EOL Announcement

Due to force majeure factors such as chips and raw materials supply discontinuation, and to achieve unified management of product models and styles, 3onedata announces the end-of-sale and end-of-life dates for the IES1024 V3.0.0 series switches.

IES1024 V3.0.0 series will be phased out in the near future, and new products IES1100 V1.0.0 will be released to meet the needs of customers.

Table 3：Appearance of the IES1024 V3.0.0 (left) and IES1100 V1.0.0 (right)

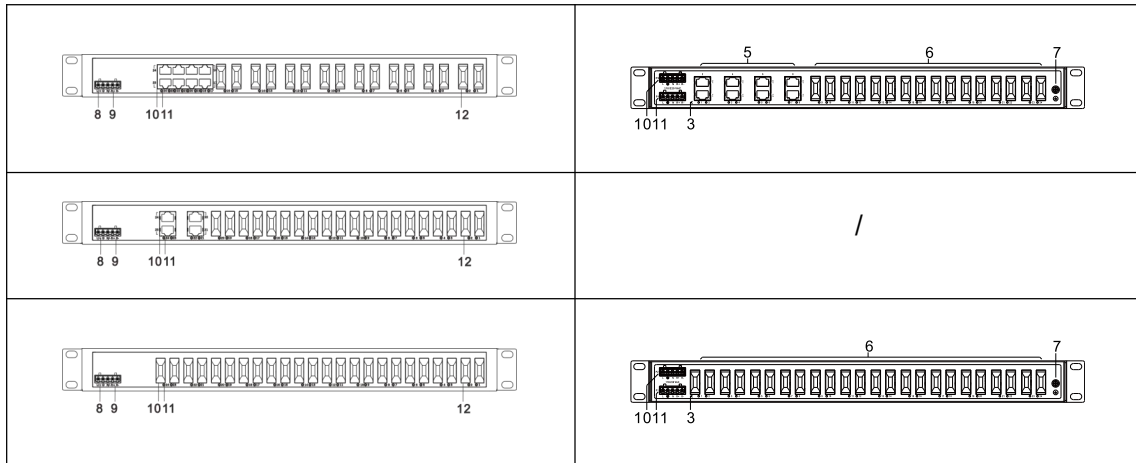
Differences between IES1024 V3.0.0 series and IES1100 V1.0.0 series are as follows：

1. Dimension (W x H x D)

The dimension of IES1024 V3.0.0 series is 441.6*44.6*207.9mm. The size of the IES1100 V1.0.0 series is 440*44*207mm.

2. Power Supply

The IES1024 V3.0.0 series supports single or dual 100~240VAC/DC, 12~36VDC, or 36~48VDC power supply. The IES1100 V1.0.0 series supports dual 18~72VDC or 85~264VAC/DC power supply.

3. IP Rating

The IES1024 V3.0.0 series is IP30 protection level. The IES1100 V1.0.0 series is IP40 protection level.
